# REPAIR OF THE INVERTED GEAR RACK IN-WALL (SCHWINTEK) SLIDE-OUT SYSTEM

TSB Number:	146-001-2022		
Product:	Inverted Gear Rack In-Wall Slide-Out System manufactured between October 2021 and January 2022		
Date:	June 24, 2022	Labor Rate:	5.0 Hours Allowed (2.5 hours per side)

**NOTE:** This bulletin supersedes service bulletin 146-001-2022 dated June 22, 2022, which should be removed from your files. This revision provides clarification around the repair kits and corrects an error in kit "C" in the parts tables.

## Repair Kit Components

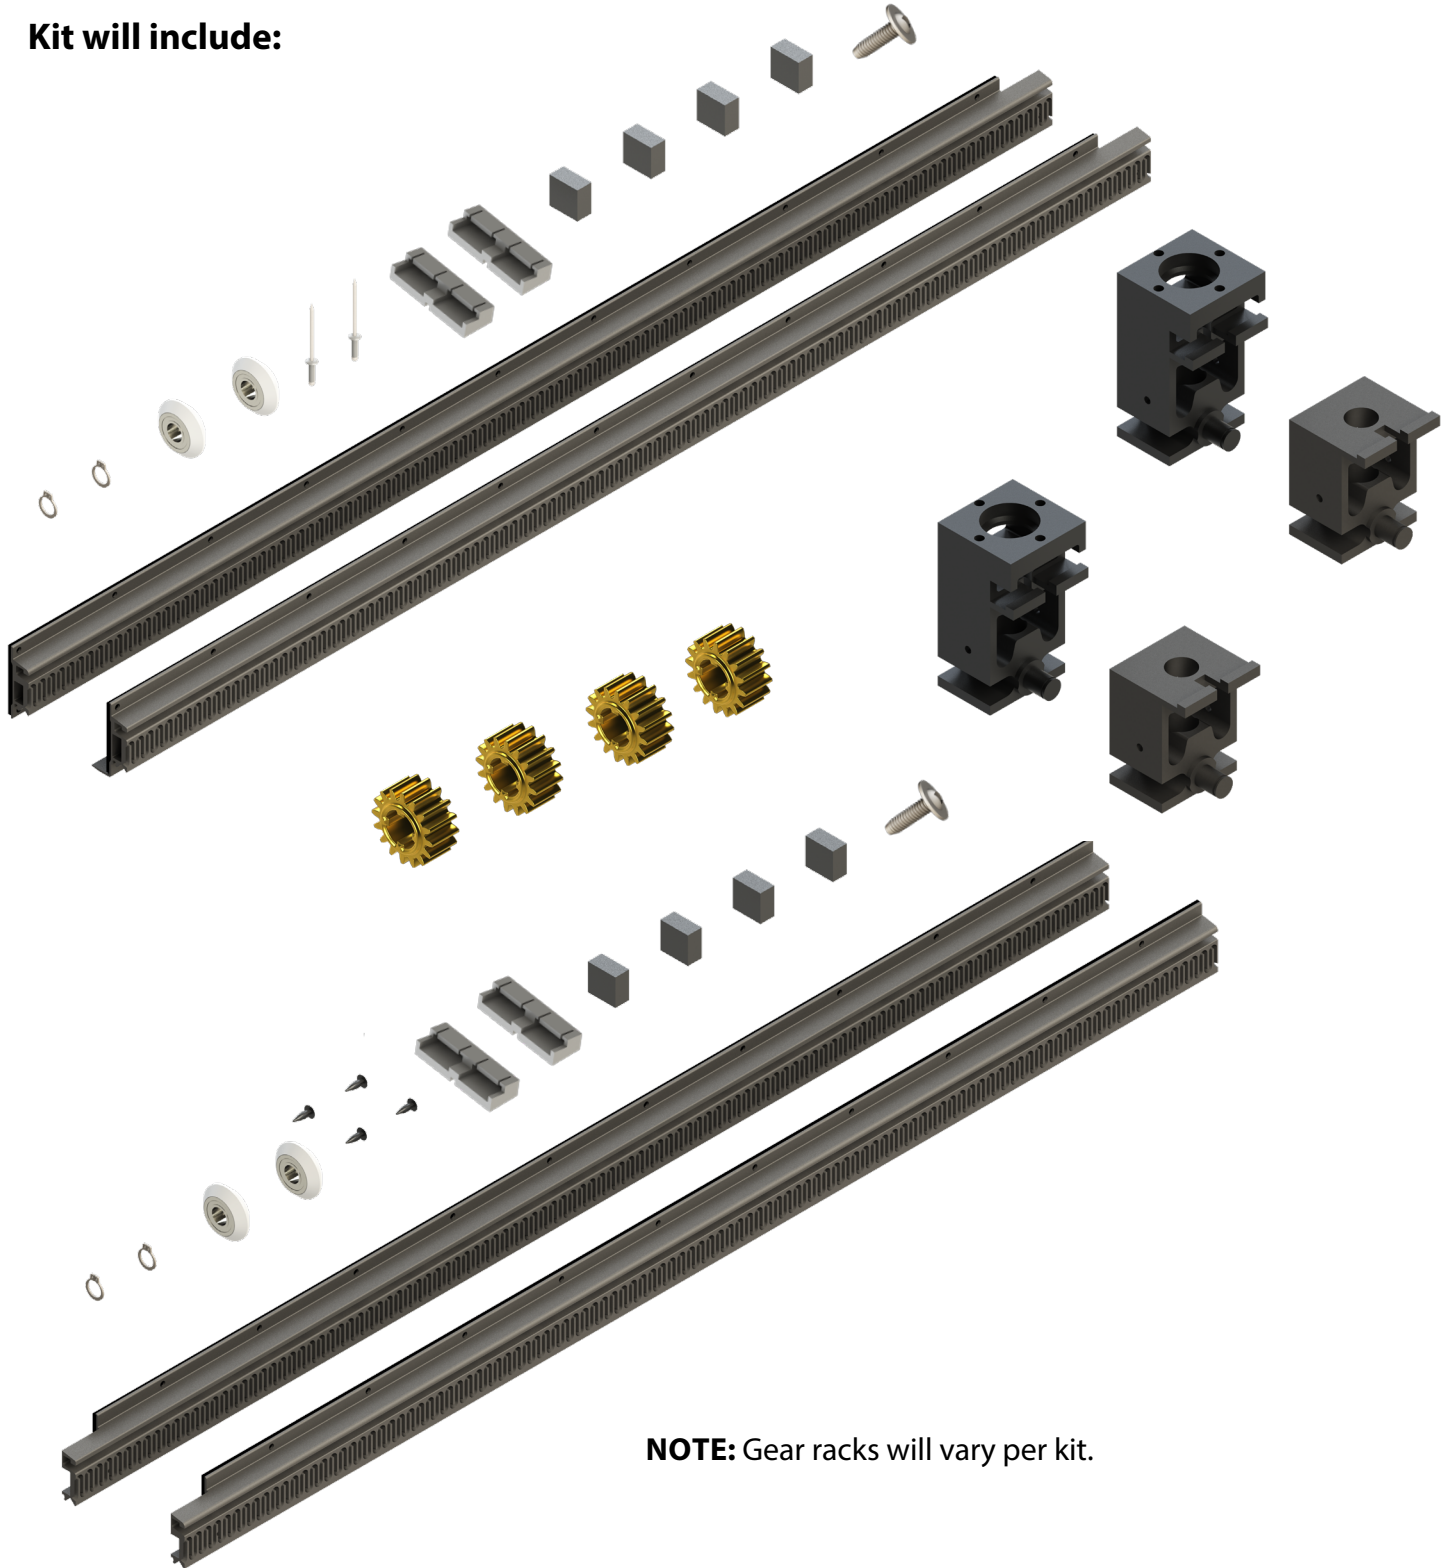
Repair kits with all parts listed for an inverted gear rack for the fixed and float repair would include:

- (1 ea.) Lower inverted gear rack fixed side (varies per kit)
- (1 ea.) Upper inverted gear rack fixed side (varies per kit)
- (1 ea.) Lower inverted gear rack float side (varies per kit)
- (1 ea.) Upper inverted gear rack float side (varies per kit)
- (2 ea.) Inverted upper bearing block (299076)
- (2 ea.) Inverted lower bearing block (299075)
- (4 ea.) Spur gear (238893)
- (4 ea.) V-Roller (292801)
- (4 ea.) Snap ring (234180)
- (2 ea.) Aluminum rivet (239423)
- (4 ea.) Inverted shoe (701196)
- (8 ea.) Flat back rack plug (318803)
- (4 ea.) Plastic pin (350596)
- (2 ea.) Motor retention screw (2021099912)

**NOTE:** The kit includes replacement parts for both the fixed and float sides of the system. It is important to replace BOTH sides and use ALL of the components when repairing units built during the October 2021 through the January 2022 timeframe.
